CALIFORNIA COASTAL COMMISSION

STAFF RECOMMENDATION

ON CONSISTENCY DETERMINATION

| Consistency Determination No. | CD-061-10 |

EXHIBIT 3
 CD-061-10
 St. Andrews Site - Footprint

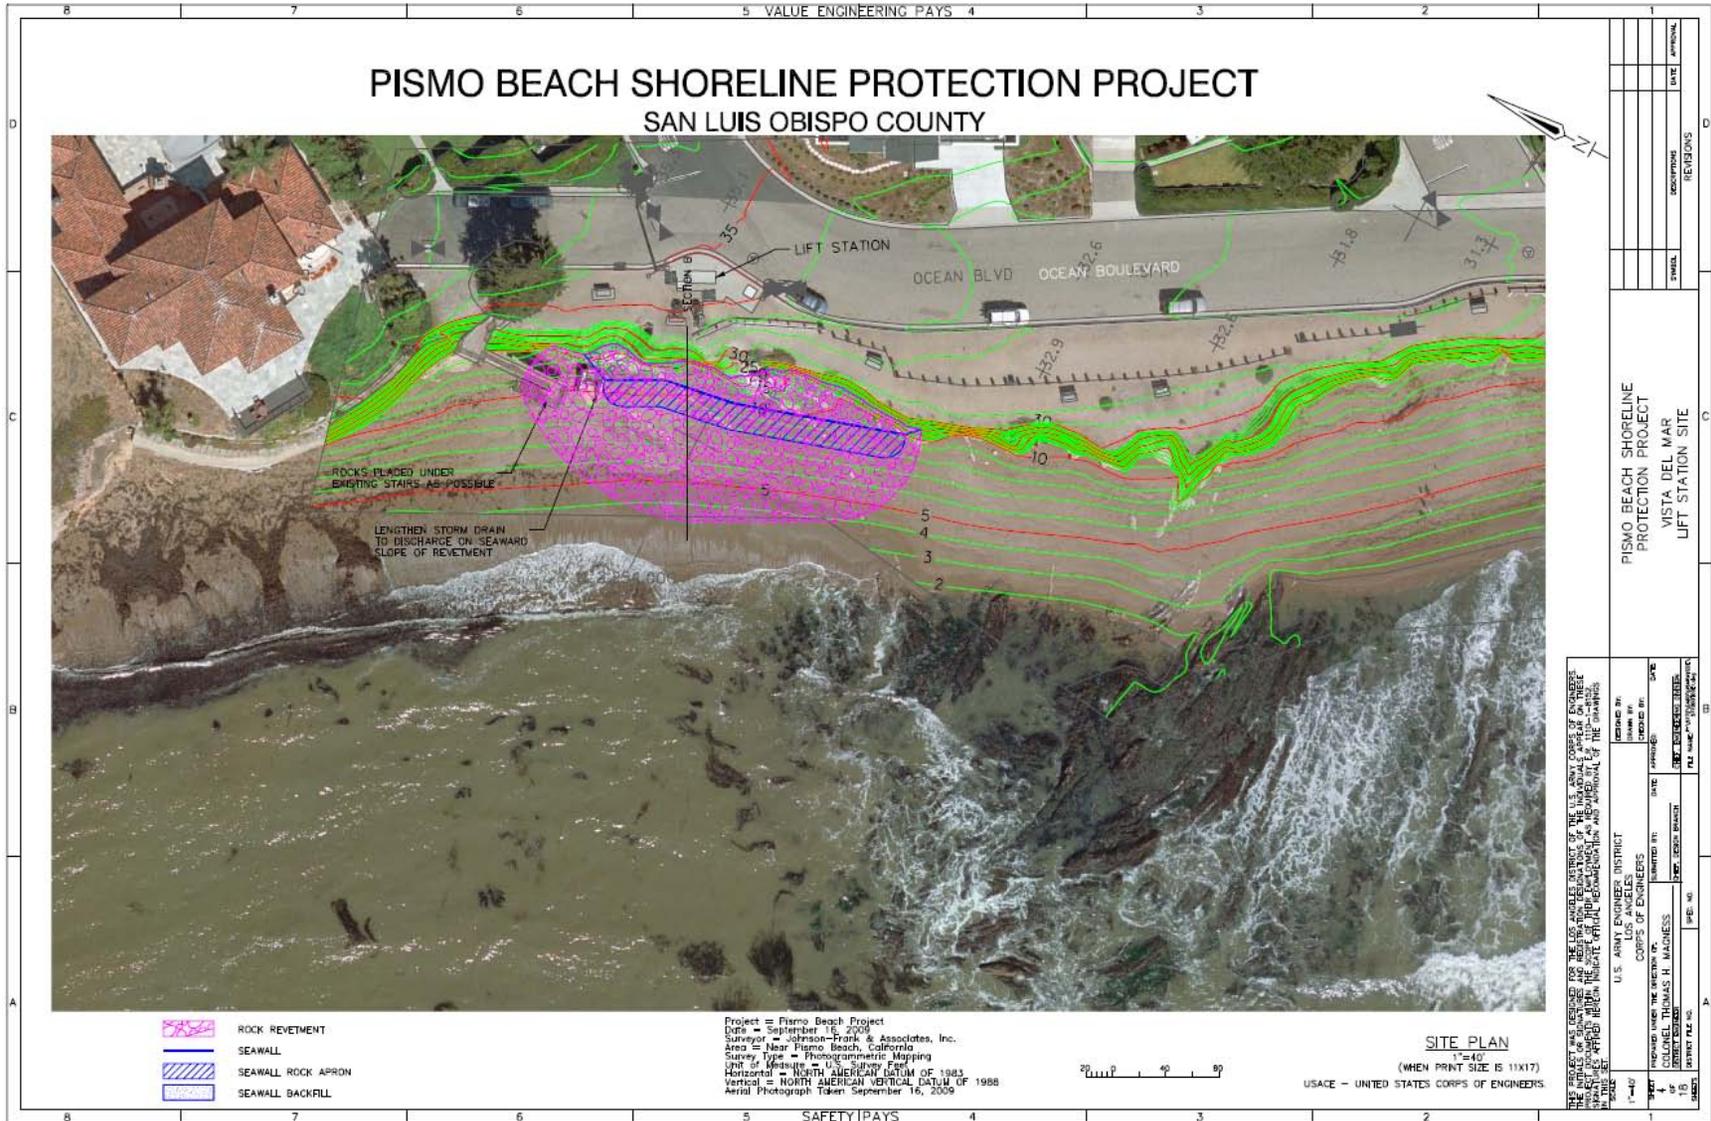
10. Detailed Site Plans & Previous Development. The scale of the 8.5 x 11 include plans contained in the EA makes them difficult to read. In addition, they do not depict the curved wall at the Vista del Mar Site – they only show a straight wall. Also, at this scale we cannot see how the proposed wall at St. Andrews is intended to intersect and/or replace the existing wall at that site. As we requested previously (and hopefully the City could provide this if the Corps does not have access to this information), we would appreciate narrative description of the history of all existing structures at the project sites, including seawalls, riprap and rubble. All City permits authorizing such development since 1972 should be identified. Also, please provide a description of how the project would incorporate or remove the existing structures and/or riprap or rubble.

Full scale plans have been requested from the Corps' design consultant and will be provided to the Coastal Commission staff. The St. Andrews site has a seawall on the adjacent property. The intent is to overlap the proposed seawall over the existing, adjacent seawall and not try to tie into what is probably a substandard seawall. Vertical and sculpted seawalls at all sites have the same footprint.

EXHIBIT 5
 CD-061-10
 St. Andrews - Revetment

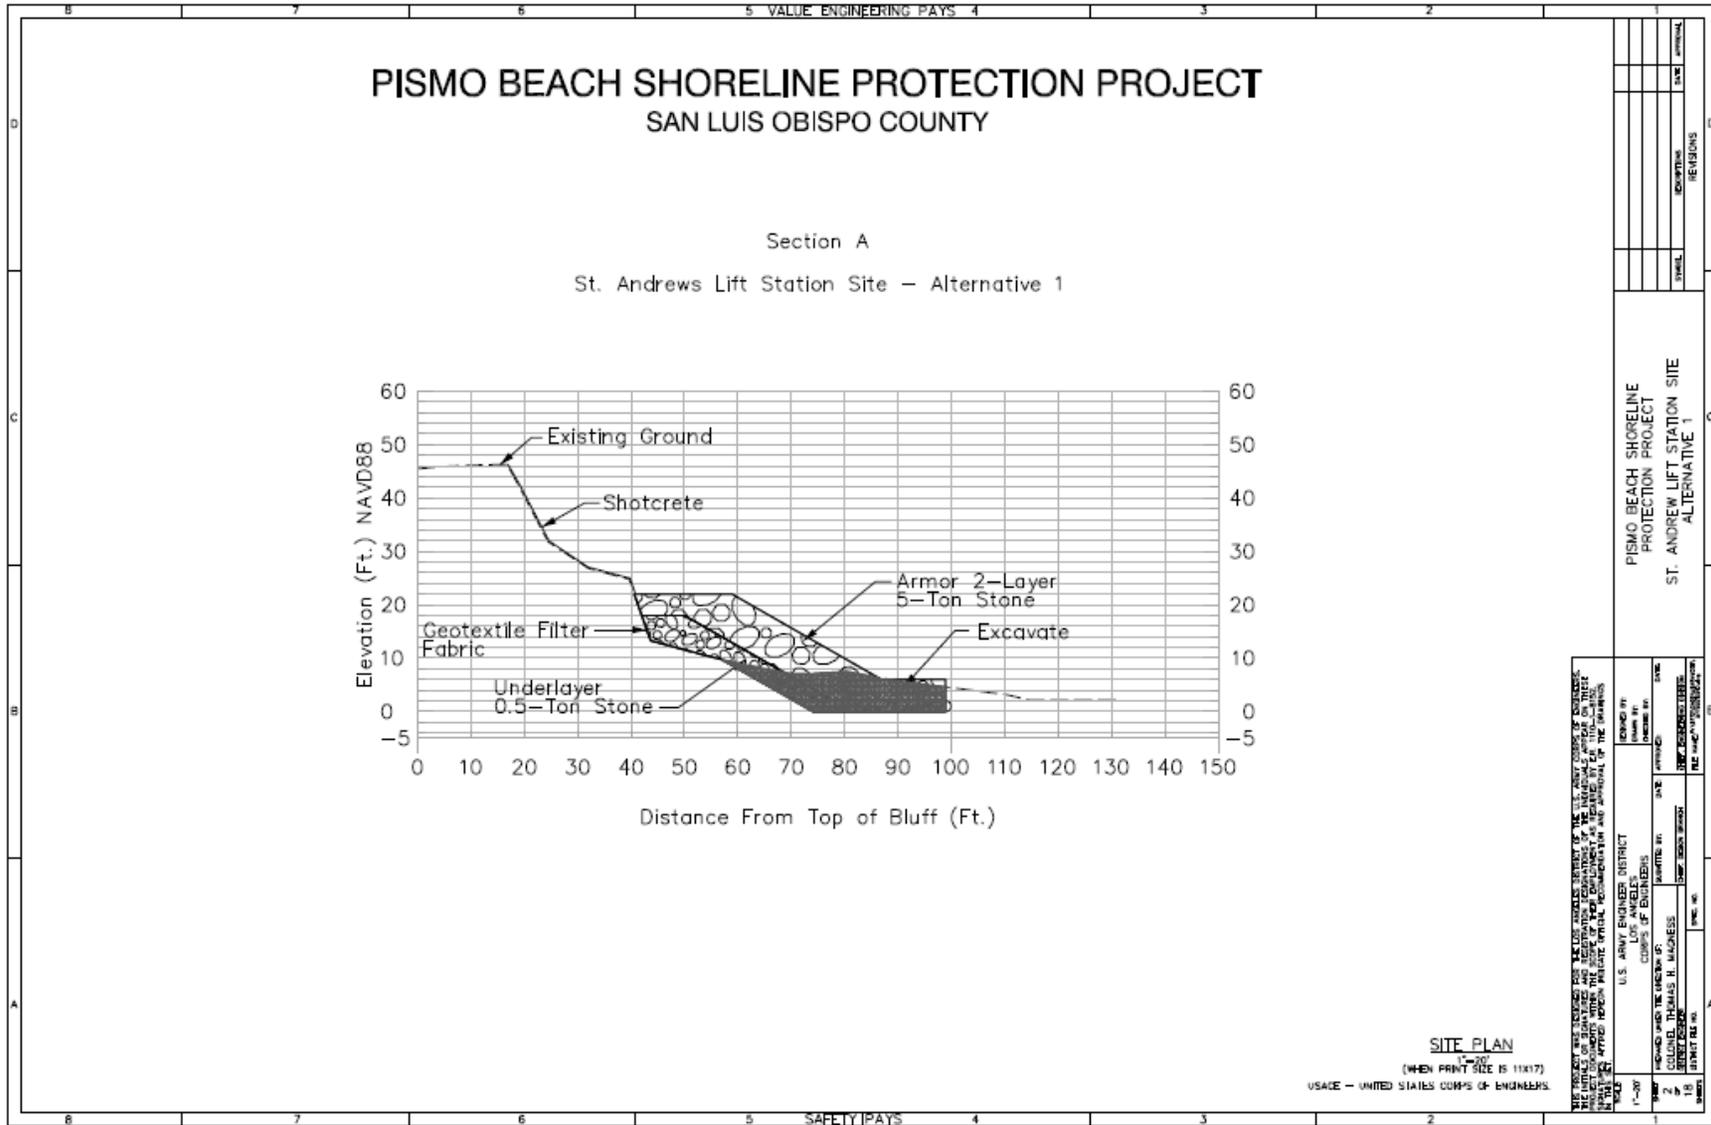
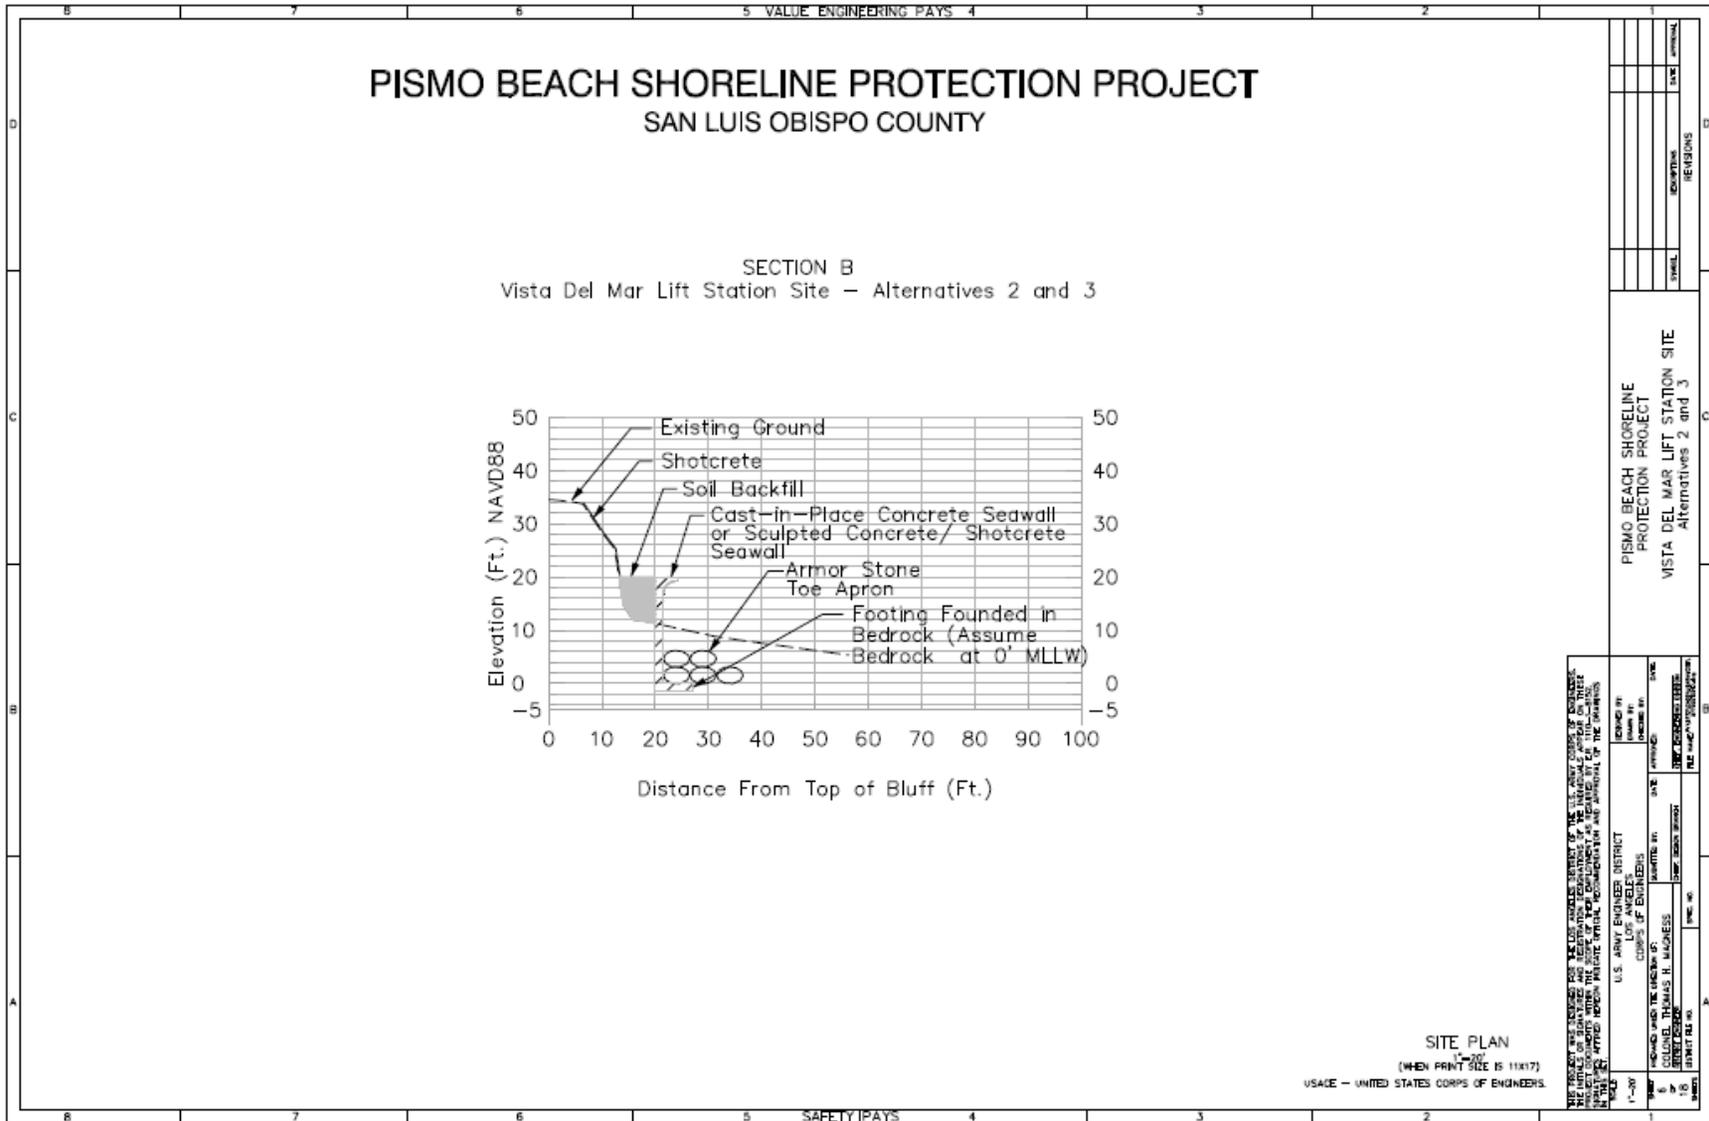
Revised Vertical Wall Design: The apparently agreed-upon replacement of the wall at St. Andrews from a rock revetment to a vertical concrete wall, similar in design to what is proposed for the shoreline protection at Vista Del Mar, is an improvement over the original proposal. If the Commission’s analysis of this project reaches the point that the Commission agrees that one or more areas are at risk and that in-situ protection is appropriate, a vertical wall would be a preferable option to a revetment. A vertical wall would reduce beach encroachment and, with coloring and texturizing, could be designed to minimize visual impacts. However, the proposed design for a vertical wall with a sculpted face would require design modifications to the Corps design that minimize impacts. The proposed wall design appears to be essentially a straight line, set several feet seaward of the bluff. A more preferable alignment would have an undulating base and the wall would be as far inland as possible with an alignment that would follow the contours of the existing bluff. One reason for the proposed design – an upright wall with back fill between the bluff face and the wall – is that the backfill area will accommodate sloughage from the upper bluff. However, the proposed design would put a layer of shotcrete over the upper bluff, so the shotcrete should minimize any concerns about upper bluff sloughage.

Recurved Wall: The analysis by Moffatt-Nichol and the small-scale designs for the vertical wall show a recurved element on the top of the vertical wall. The vertical wall height design depends upon this recurve feature. The description of the vertical wall does not call out this feature. If the Commission’s analysis of this project reaches the point that the Commission agrees that one or more areas are at risk, that in-situ protection is appropriate and that a vertical wall is the best option, this recurved feature will need to be included in the final design and shown clearly on the final plans, or the wall height needs to be adjusted to account for the lack of a top recurved element.

Assuring Wall Toe Keyed to Bedrock: The proposed plans for the vertical wall show that the wall will be founded in sand at a depth of 0’ MLLW. The project discussion mentions that the bottom of the wall will be keyed into bedrock. If the Commission’s analysis of this project reaches the point that the Commission agrees that one or more areas are at risk and that in-situ protection is appropriate, either the plans or the discussion should be modified to correctly present the bedrock position and, the toe should be deep enough that it is safe from scour.
